SUBJECT: Mooney M20M, Retrofit, cabin exhaust vents on fuselage sides/cabin ventilation system modification.

AFFECTED: PART 1: M20M - S/N 27-0002 THRU 27-0137 (EXCEPT S/N 27-0094)
PART 2: M20M - S/N 27-0053 THRU 27-0167 (EXCEPT S/N 27-0094)
PART 3: M20M - S/N 27-0002 THRU 27-0052

FIGURE 1

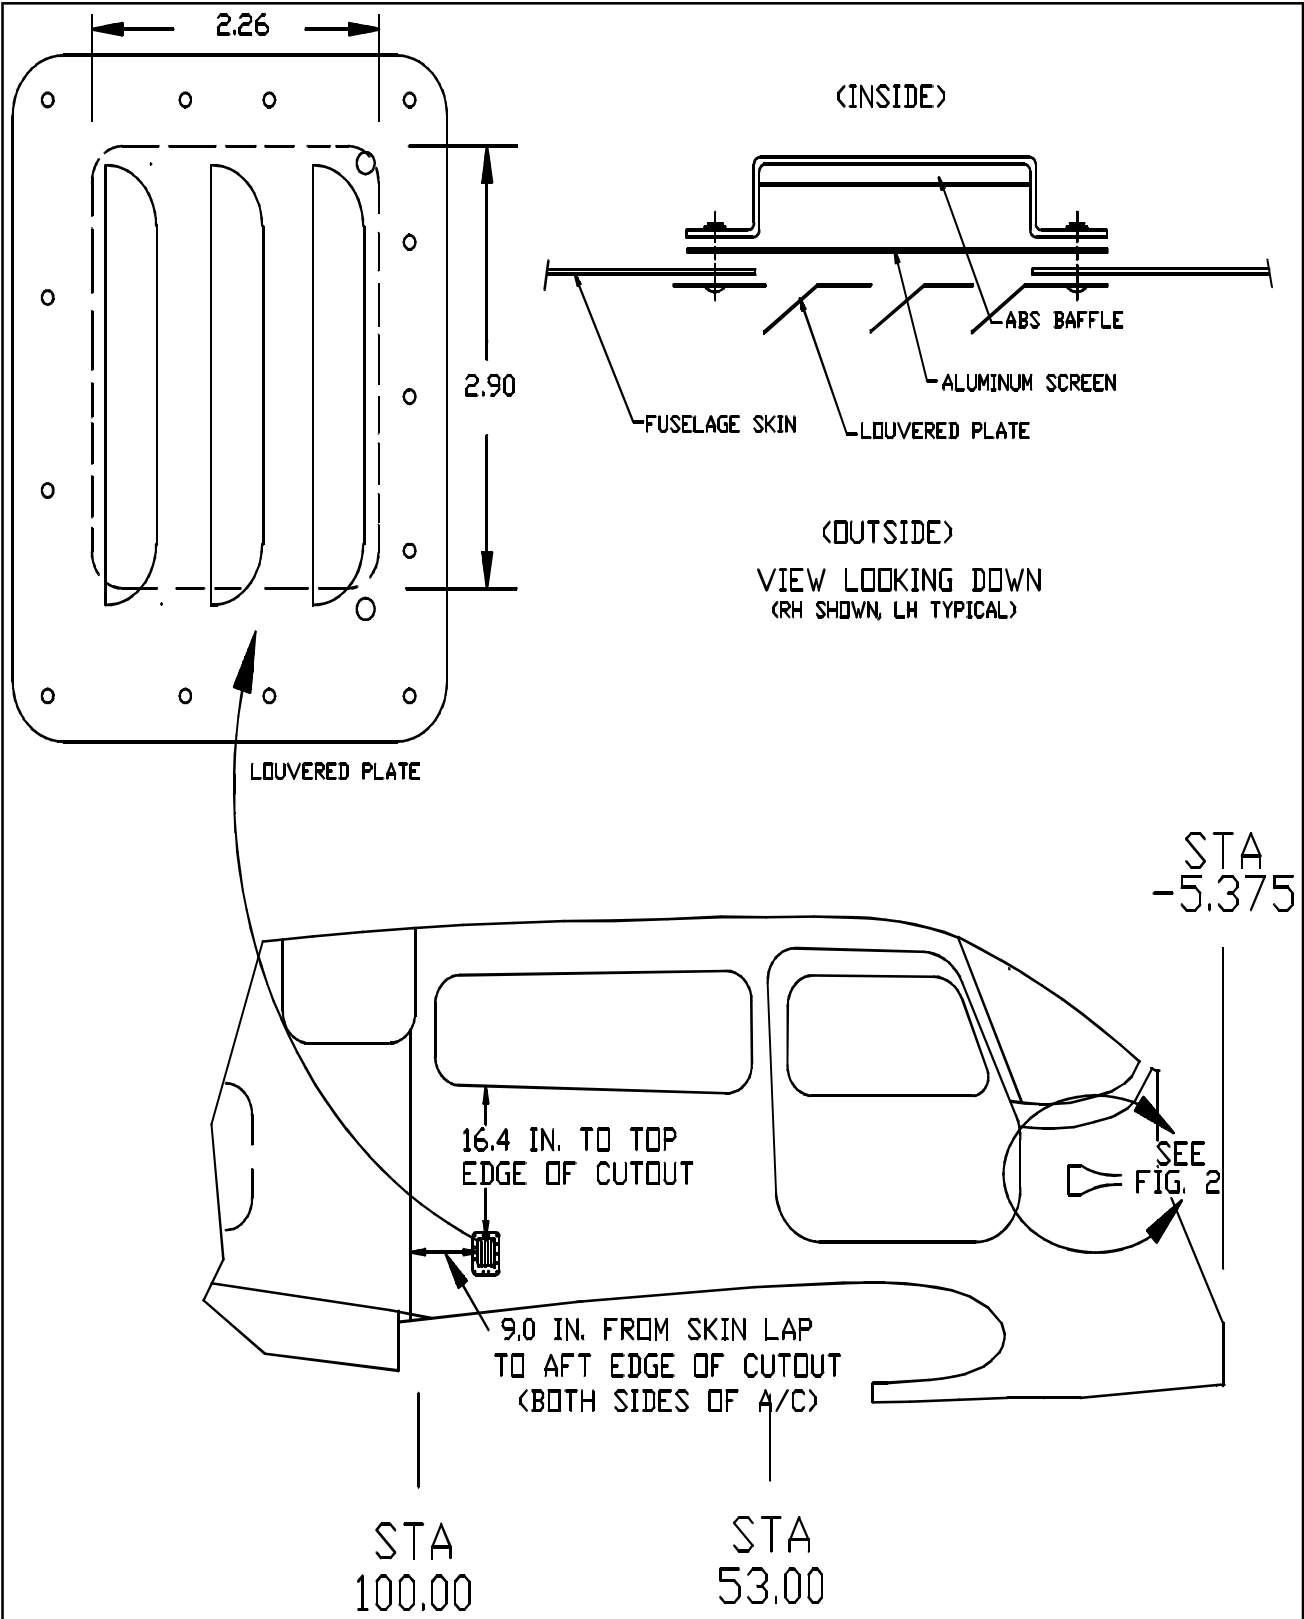
PART 1: ADD CABIN EXHAUST VENTS (FIG. SB M20-255-1)
(S/N 27-0002 thru 27-0167, excluding S/N 27-0094)

2. Locate area of fuselage skin to be cut out by measuring from the baggage compartment/cabin area, vertical skin lap, forward, 9.0 inches and down 16.4 inches from lower edge of aft window skin cut-out. The size of each cut-out should be 2.9 inches high and 2.26 inches wide. Keep vertical sides of cut-out parallel with vertical skin lap. Recommended radius on all corners of cut-out is .125 inches. (Fig. SB M20-255-1)

6. Place R/H 640130-000 louvered plate in position, over R/H cut-out hole, in accordance with Fig. SB M20-255-1. The location of the louvered plate does not have to be exact, however, a minimum of .31 inches edge distance should be maintained for all fasteners. Drill #30 holes in fuselage skin to match #30 holes in louvered plates (13 places for each plate). Reference Fig. SB M20-255-1. Repeat for L/H cut-out hole.

7. Install R/H louvered plate (outside of fuselage skin), R/H aluminum screen and 640296-002 ABS baffle (inside of fuselage skin) with Avex 1691-0410-05 rivets and AN960-6 washers. Sandwich aluminum screen between ABS baffle and inside surface of fuselage skin as shown in Fig. SB M20-255-1. Repeat for L/H side.

FIGURE 2

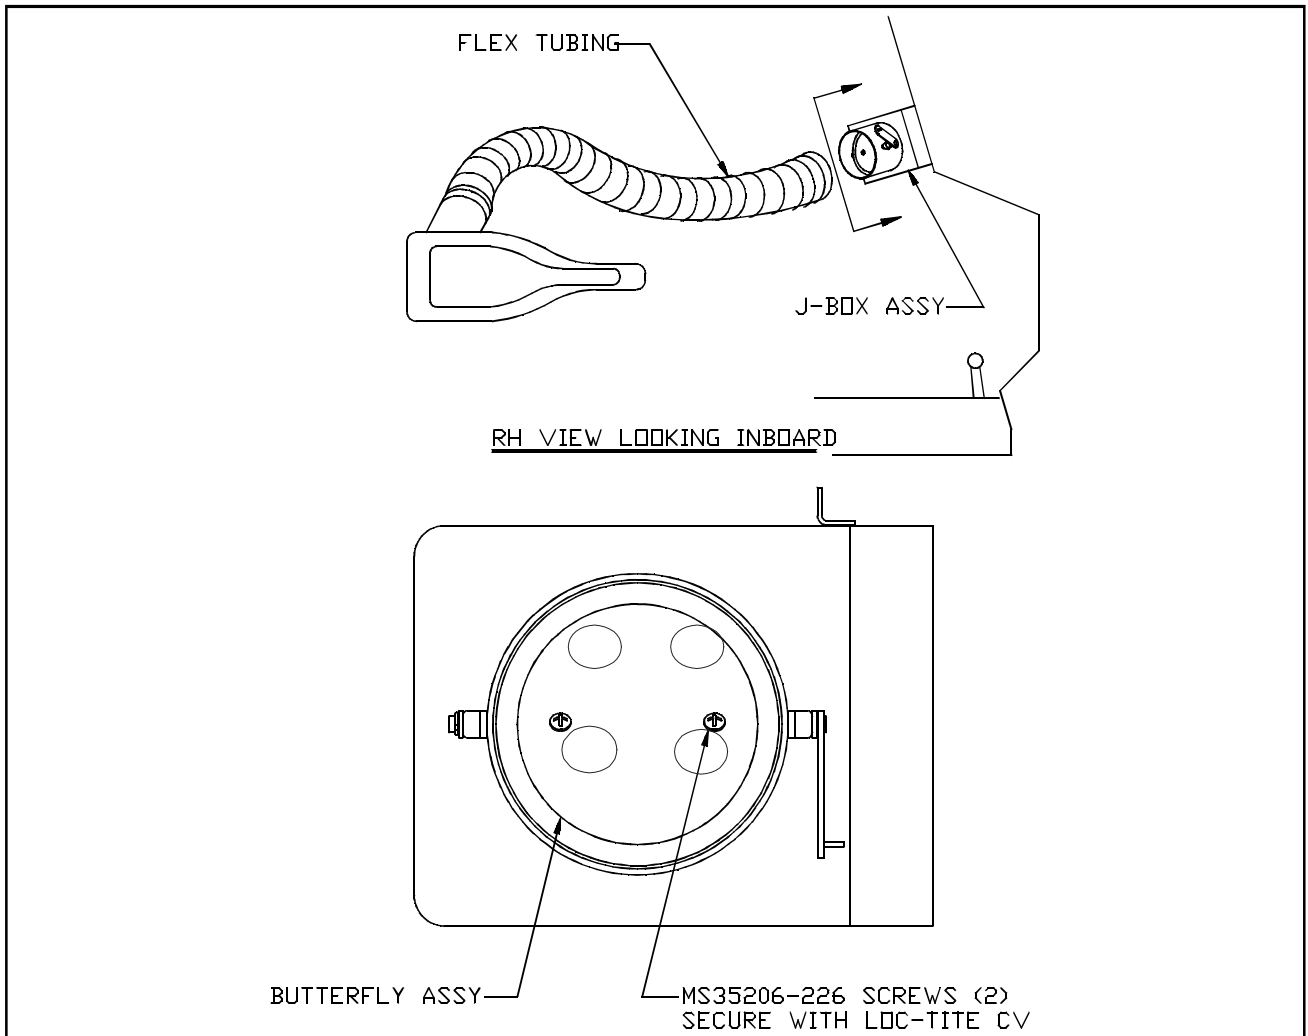
PART 2: REPLACE BUTTERFLY ASSEMBLY IN CABIN VENTILATION J-BOX (FIG. SB M20-255-2)
(S/N 27-0053 THRU 27-0167, excluding S/N 27-0094)

1. Locate cabin ventilation J-Box in forward, RH cabin immediately behind firewall.
2. Access J-Box assembly by loosening QS100-M40S clamp at J-Box and flex tubing connection; replace existing 640326-505 butterfly assembly with new 640326-511 butterfly assembly, Fig. SB M20-255-2.
3. Re-install flex tubing to J-Box with QS100-M40S clamp.
4. Enter compliance note in log book and return aircraft to service.
5. Fill out and return pre-addressed, stamped compliance card.

FIGURE 3

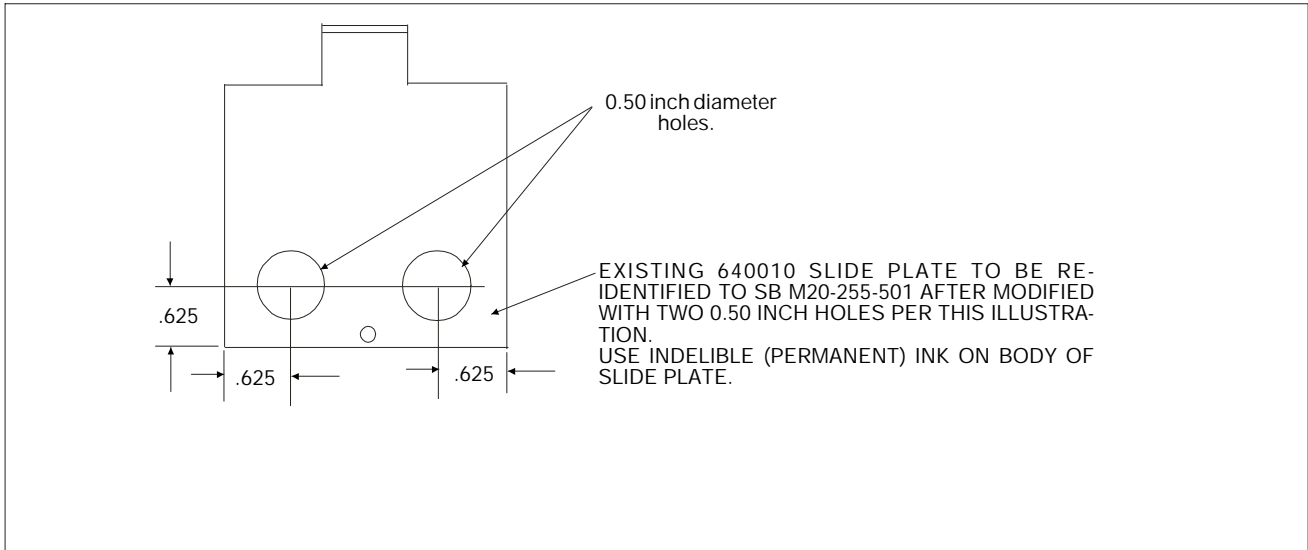
PART 3: MODIFICATION OF SLIDE PLATE ON CABIN VENTILATION J-BOX. (FIG. SB M20-255-3)
 (S/N 27-0002 THRU 27-0052)

3. Modify 640010-000 slide plate by drilling two 0.50 inch diameter holes, in locations as shown in FIG. SB M20-255-3. Slide Plate must now be re-identified as P/N SB M20-255-501; use indelible ink to mark P/N on body of slide plate.
